Plan Change Request

➤ Specify the approved civil plans affected: PRPF20251347

PCR 01 PRCCP20260217

Marcoe's Building
Relocation

C1-102

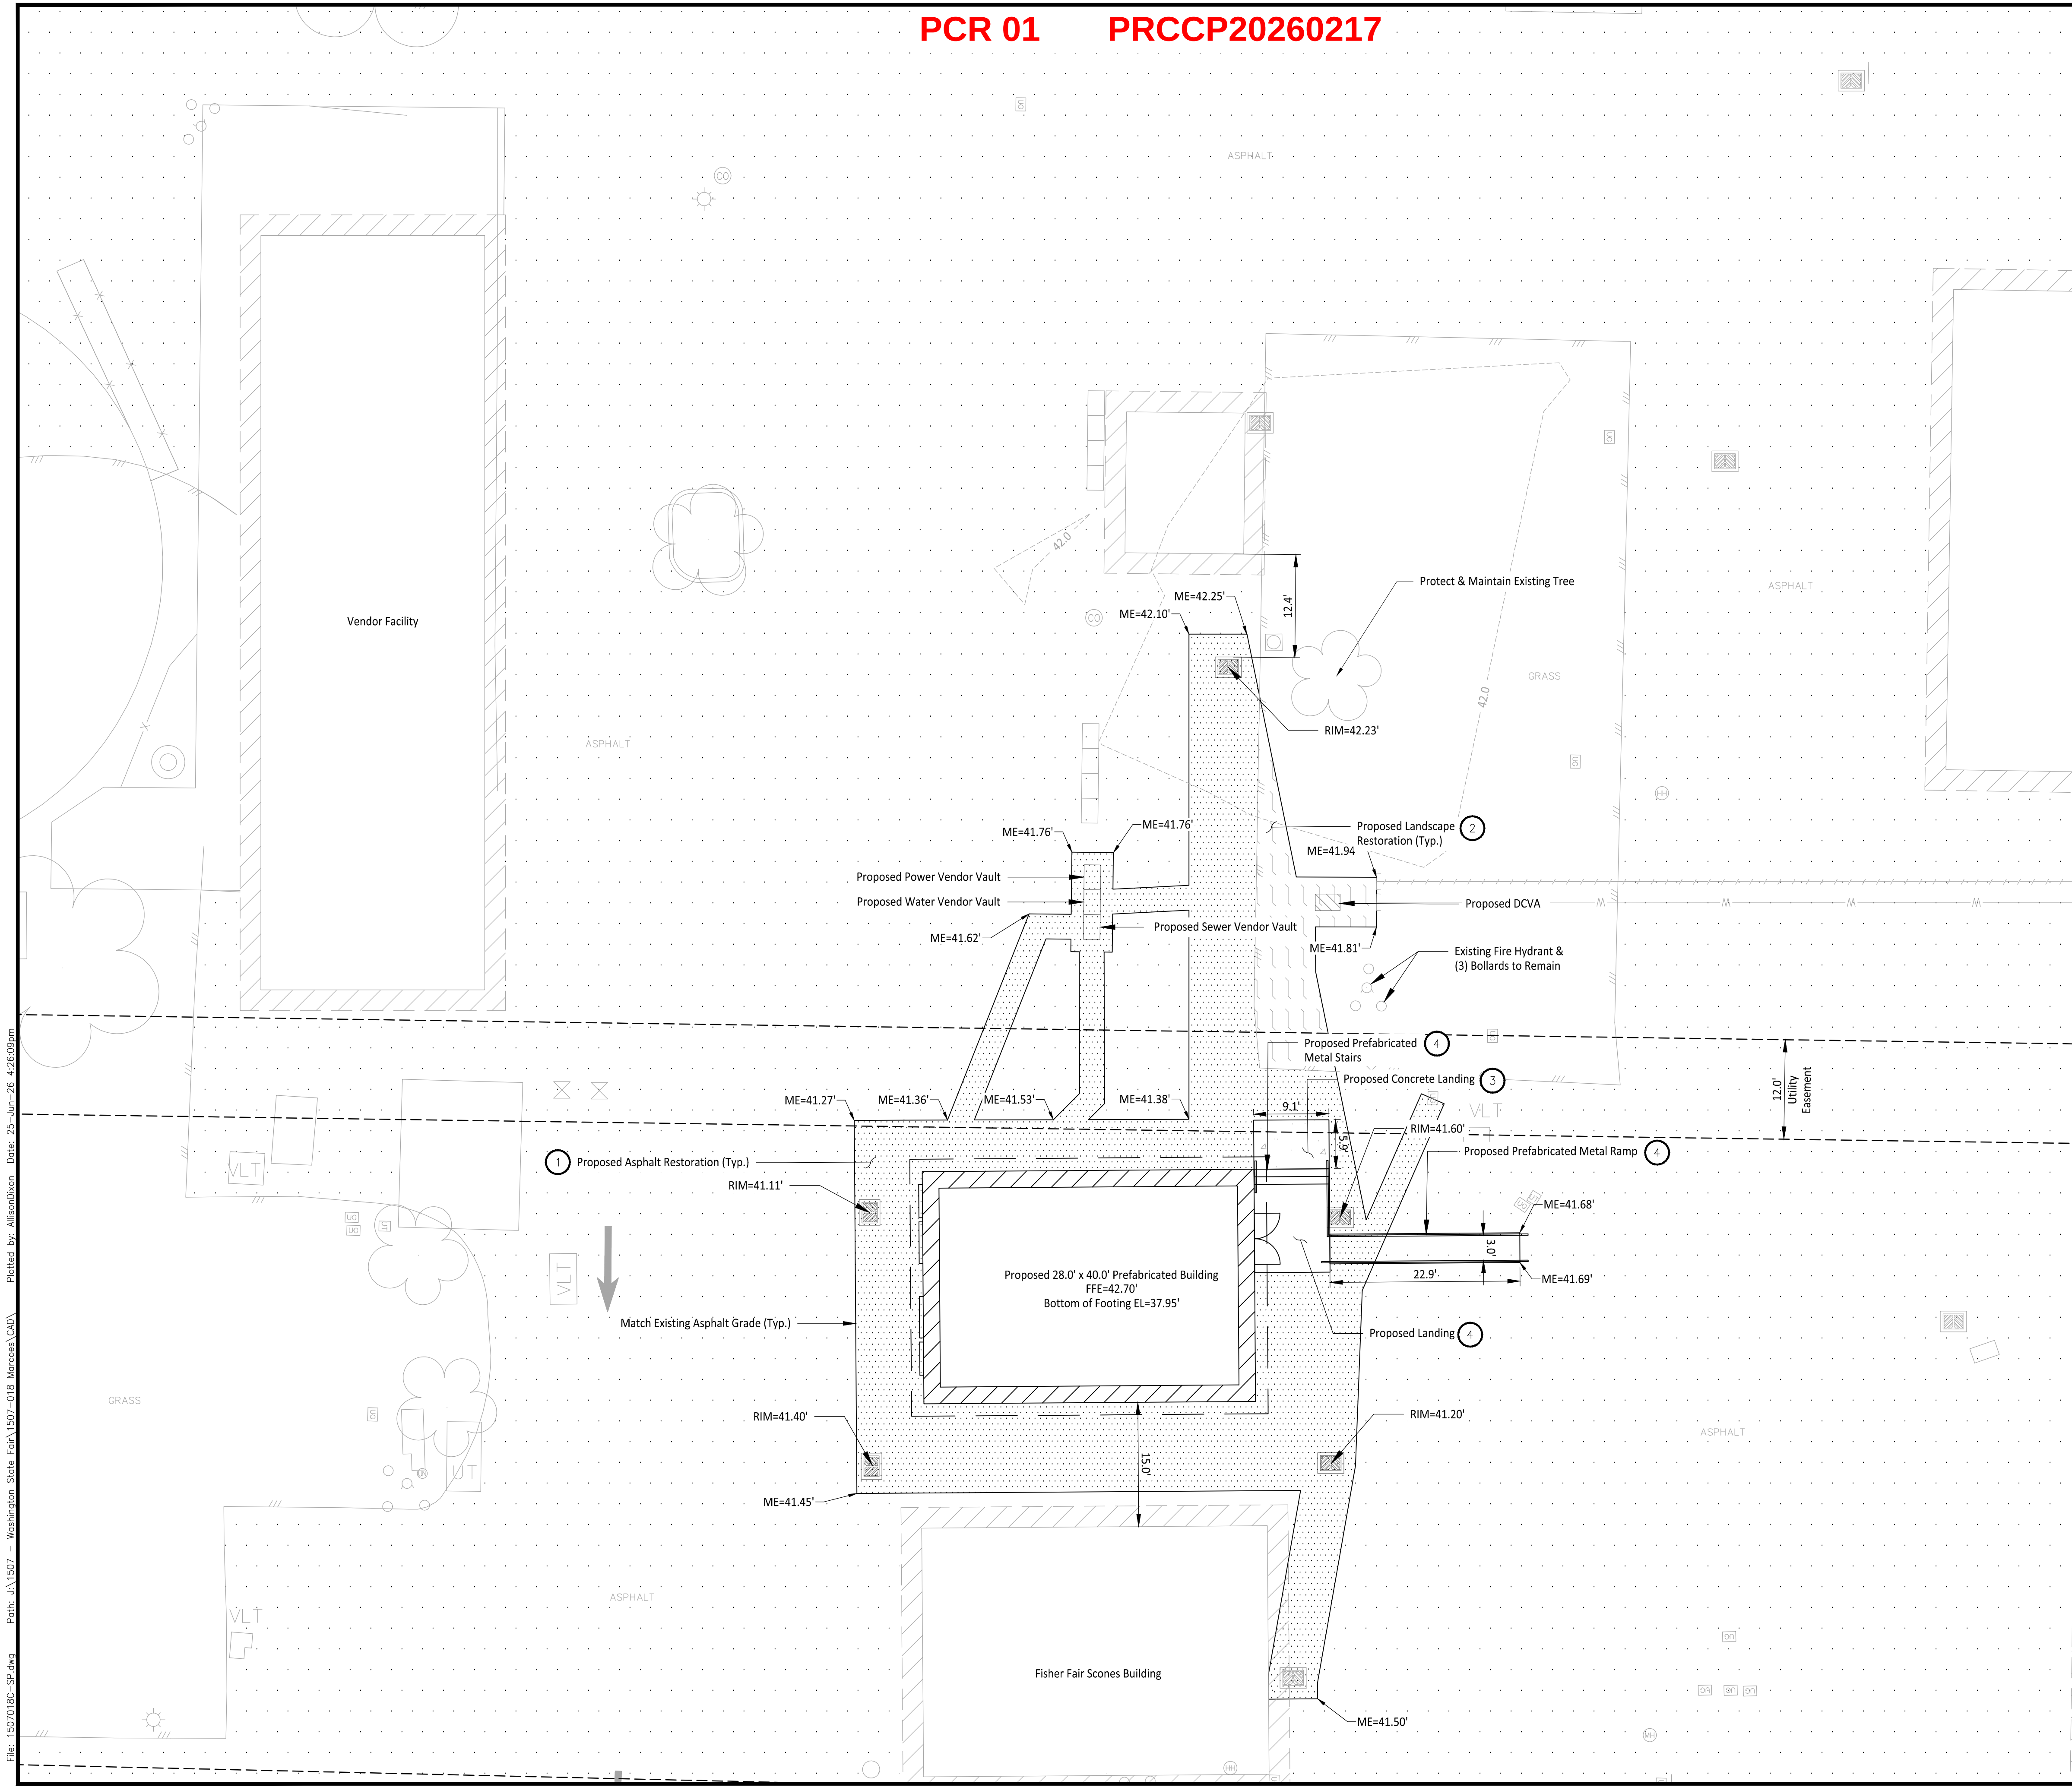
During demolition of the existing building a primary power line was encountered. Changes to the plan set include relocating the proposed building and all effected utilities.

REV	DATE	DESCRIPTION
1	05/05/26	Revised per City Comments
2	06/25/26	PCR 01
